Subject: TICKING NOISE FROM PURGE VALVE	Bulletin No: 01-012/07
	Last Issued: 05/07/2007

BULLETIN NOTE

2005 - 2007 Mazda6 3.0L vehicles produced before Oct. 10, 2006

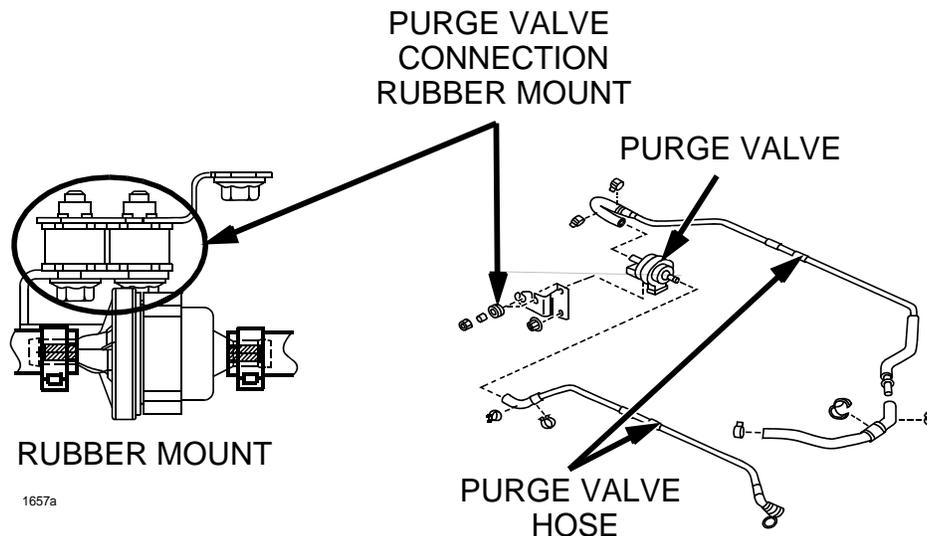
On some vehicles, a ticking noise can be heard in the vehicle cabin during slow acceleration between 900 - 1200 RPM. Due to purge valve operation, (located on bulkhead) vibration may occur and transmit noise into the vehicle cabin through the bulkhead and dash panel. As a mass-production improvement, the length and diameter of the rubber mount was increased, and the rubber was hardened. The purge valve hoses were also lengthened.

1. Verify customer concern.
2. Replace purge valve installation rubber mount and purge valve hoses with modified parts.
